Response to Agency Preliminary Comments on Labadie Energy Center §316(a) Draft Demonstration Study Report

This document provides responses to comments received from agencies in conjunction with Ameren's submittal of the Labadie Energy Center §316(a) Draft Demonstration Study Report. Ameren Missouri has reviewed the comments provided by the Missouri Department of Natural Resources (MDNR) on behalf of the Agency and the Missouri Department of Conservation (MDC). Ameren also received comments from the Region VII of the United States Environmental Protection Agency (EPA) and the United States Fish and Wildlife Service (USFWS) via email from MDNR on December 4, 2019 and March 18, 2020, respectively. Ameren's responses to these comments are provided below. Some comments have also resulted in revisions to the Draft Demonstration Study Report and supporting materials (i.e., *Supplement to Labadie Energy Center Draft 316(a) Demonstration in Response to Agency Comments,* the "Supplement") which are referenced in the responses below.

Figure 1. Seasonal fraction of the fish community comprised of heat intolerant species as numbers (left) and biomass (right) in the vicinity of the LEC in 2017-2018.

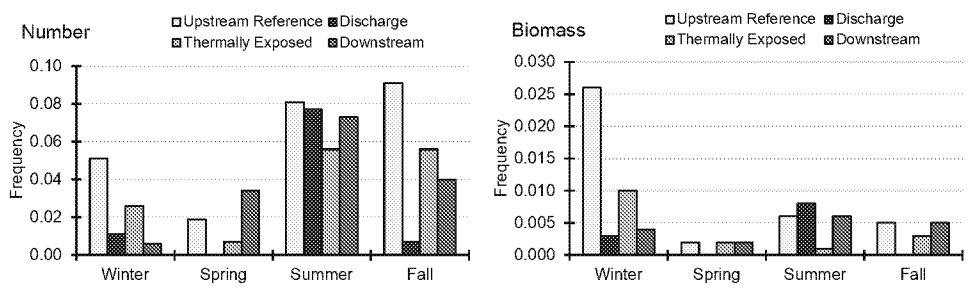
c. In addition to this, please graph these by season as Section 6.3.3 indicates certain intolerant species will be completely absent if the river exceeds certain temperatures. Seasonal density graphs were completed for the macroinvertebrate community in Figure 5-24.

c. Graphs in Section 5 were selected to illustrate patterns in the data, without overwhelming the reader with more graphics than can be assimilated. The seasonal aspect of the prevalence of heat tolerant and intolerant species was incorporated into the analysis. The data for tolerant and intolerant species, segregated by gear and season, are provided in Appendix B Tables B-14 through B-17. The standardized differences between Upstream and either Thermally Exposed or Downstream zones, based on each of these combinations for fraction intolerant species are provided in Appendix B Tables B-18 through B-21. All of the standardized differences for each combination of gear x season, for both numerical abundance and biomass (without preference) were included in the overall weight of evidence, along with differences based on other metrics, in Figure 5-22.

To satisfy the request, figures similar to Figure 1 are provided in the Supplement (Section 3) to demonstrate the seasonal component of heat-intolerant species as it relates to numerical abundance and biomass.

Figure 2. Maximum temperature at the edge of the 25% Mixing Zone vs. TDP

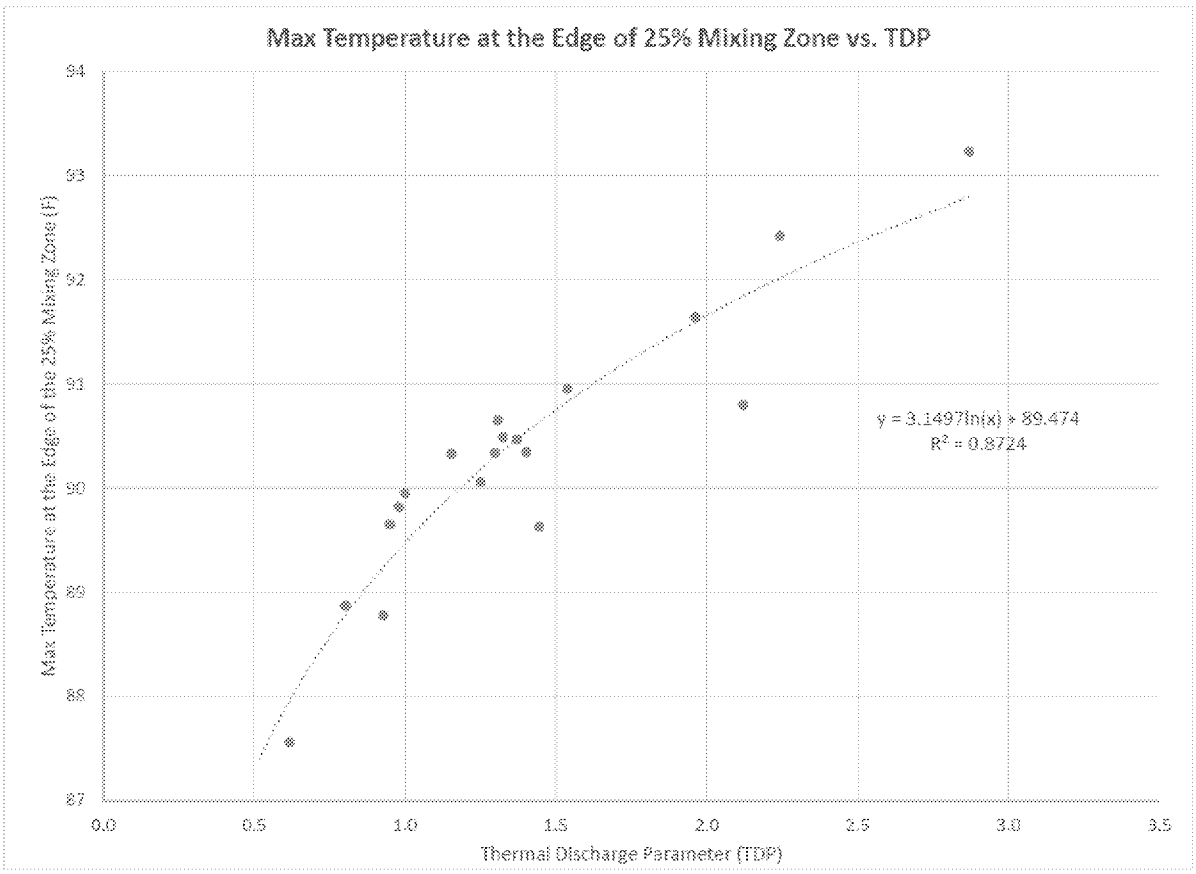
7. The Ameren variance request appears to be based on the logic of the Mississippi River criteria and this seems appropriate. The questions/comments below are based on that approach. While variable with river temperature, what is the more elevated temperature (>5°F) at the edge of the 25% mixing zone when the RMZ is expanded to 40% of the river? Does this equate to an additional 3°F increase above 90°F? Is the 40% value based on a calculated zone of passage or a maximum temperature at the higher RMZ? Ameren's variance request should define the increase in temperature above 90°F when the larger RMZ is allowed.

RESPONSE: On days when the 316(a) variance is invoked, the 90°F and delta T less than 5°F requirements will always be met within a 40% mixing zone, but on those days the temperature will be either be (a) above 90°F or (b) more than 5°F above background in a 25% mixing zone. Hence the need for the 316(a) variance.

In response to this comment, we analyzed the model output from a subset of the previously conducted simulations that were run to develop the effluent limitation equations in Tables A-1 and A-2 of the NPDES permit. For each simulation, we determined the location along the river where the maximum temperature occurs after mixing with only 25% of the river flow. At all other locations, the temperature would of course be less than the maximum. The simulations analyzed represent a range of river and discharge temperatures and flows.

For most instances during which the variance may be invoked the maximum temperature at the edge of the 25% mixing zone will only be one or two degrees above 90°F. For example, as shown in Figure 2, for a TDP value of 2.3, the maximum temperature at the edge of the 25% mixing zone will still only be about 92°F. And, TDP values at or above 2.3 would be extremely rare. The historical record shows that such has occurred on only 4 days out of 6018 days (less than 0.1% of the time). So, on days when the variance will be invoked, the maximum river temperature at the edge of the 25% mixing zone will typically be around one and almost always less than two degrees above 90°F, but never above 94°F.
